RZP-2021-080

2128 W TYVOLA RD, CHARLOTTE NC 28217

[Discipline: CHARLOTTE WATER]

Summary: Water service is accessible for this rezoning boundary. Charlotte Water currently does not have sewer system accessible for the rezoning boundary under review. The development will need to donate pipeline infrastructure to CLTWATER to serve this parcel. The applicant should contact Charlotte Water's New Services at (704) 432-2854 for more information regarding accessibility to sewer system connections.

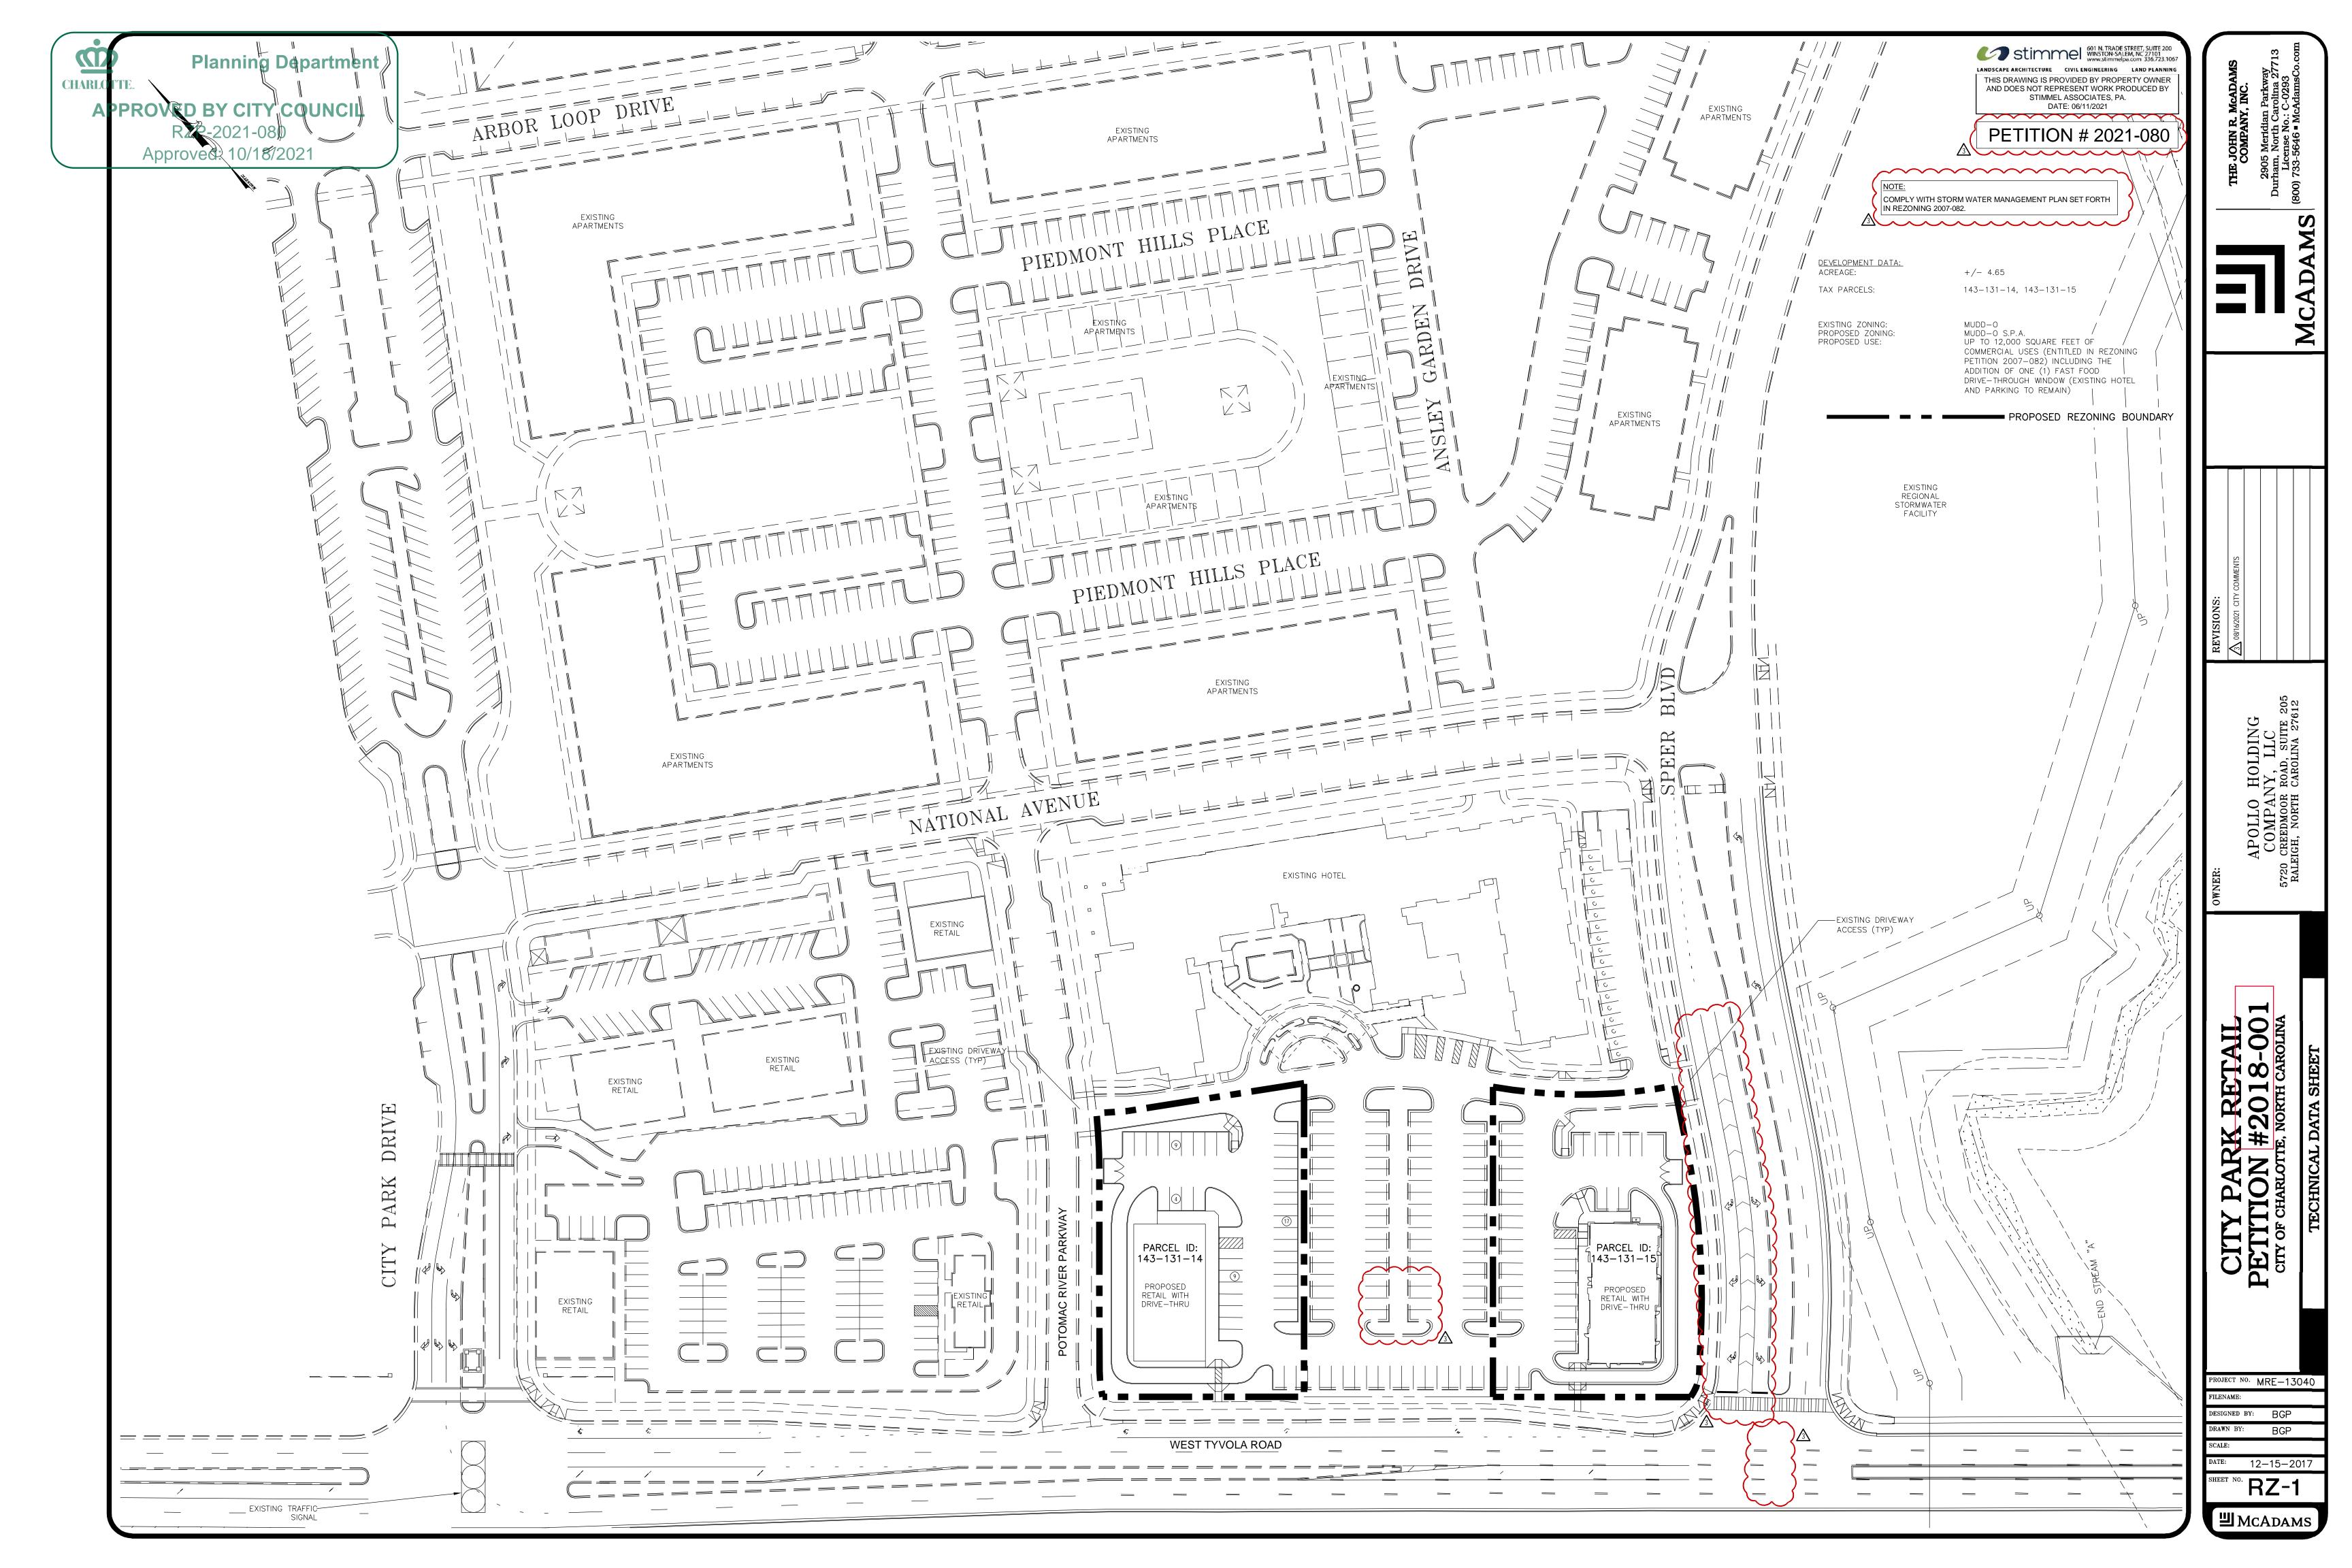
Charlotte Water has accessible water system infrastructure for the rezoning boundary via an existing 16-inch water distribution main located along Tyvola Road.

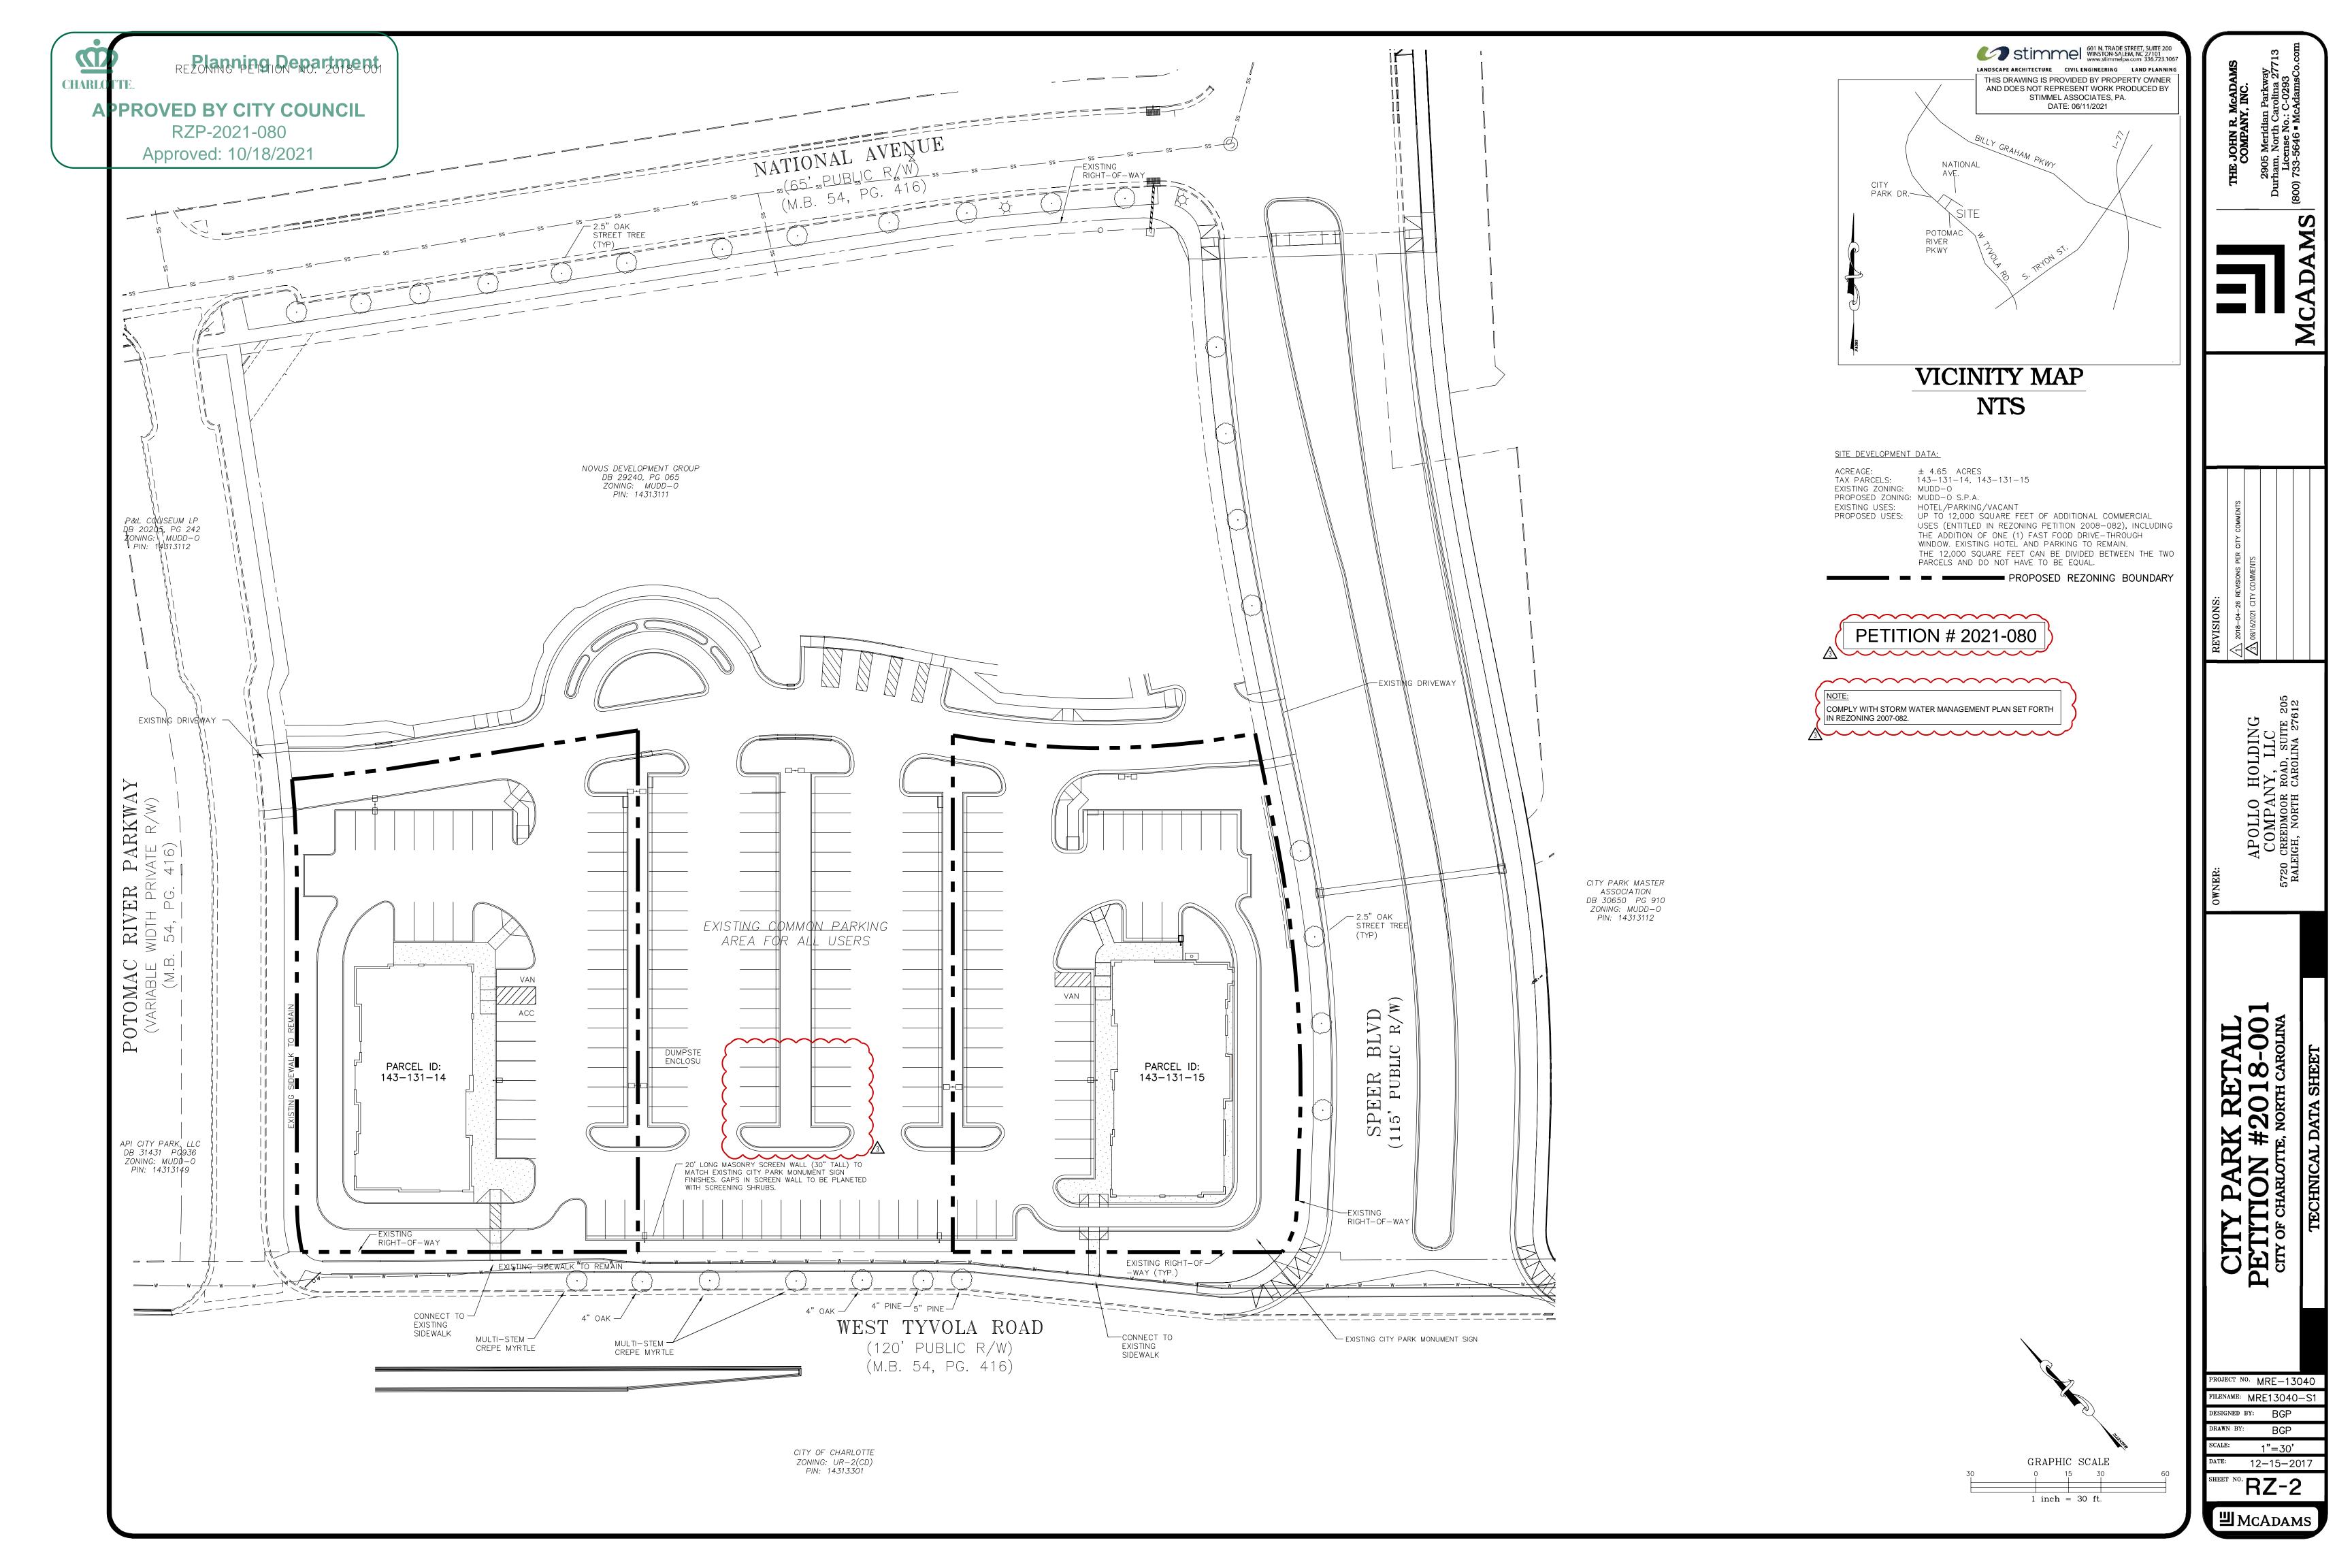
Charlotte Water currently does not have sewer system accessible for the rezoning boundary under review. The closest available sewer main is approximately 270 feet northeast of the rezoning boundary on National Ave. A developer donated project will be required in cases there is not direct service. The applicant should contact Charlotte Water's New Services at (704) 432-2854 for more information regarding accessibility to sewer system connections.

Development is encouraged to contact Installation Development Services at (704) 336-5499 to review service connection design requirements and City Ordinances (e.g., backflow, separate meter Ordinance, public/private pipeline extensions). Comments: Has direct access to water. Might have access to private on-site sewer. If not, sewer will need to be extended from National Avenue. Contact CLT Water New Services Department for water/sewer services.
